## Errata

This errata sheet is for MB95330H Series Hardware Manual Rev. 1 (CM26-10126-1E).

F<sup>2</sup>MC-8FX  
8-BIT MICROCONTROLLER  
MB95330H Series  
HARDWARE MANUAL

2012.05.11

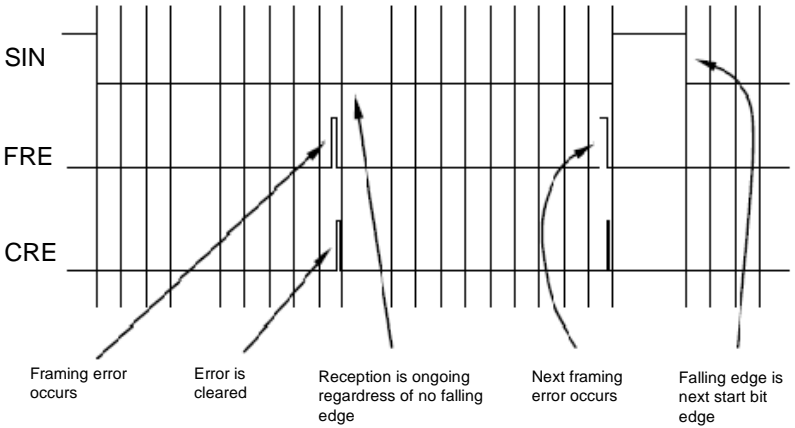
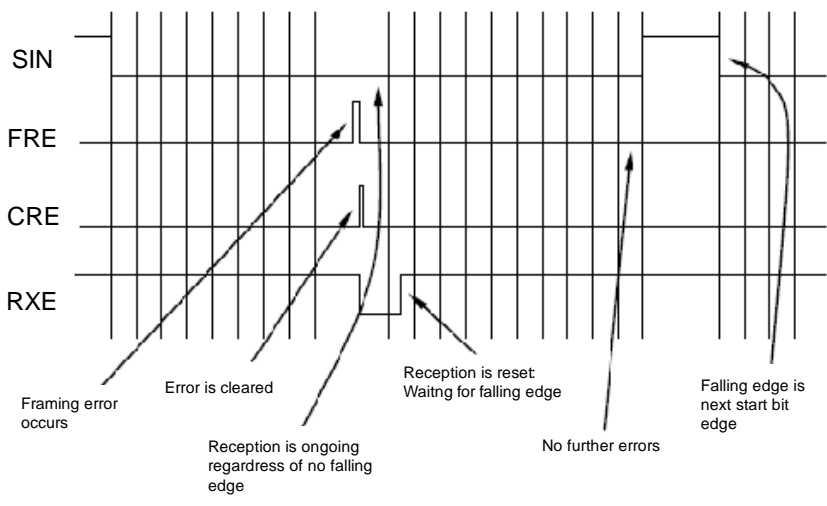
2012/05/11	356	17.8	<p>The following diagram should be added as “Figure 17.8-1 UART Dominant Bus Operation” in “● Handling framing errors”.</p> <p>When reception is always enabled (RXE=1)</p>  <p>When reception is temporarily disabled (RXE=1→0→1)</p>
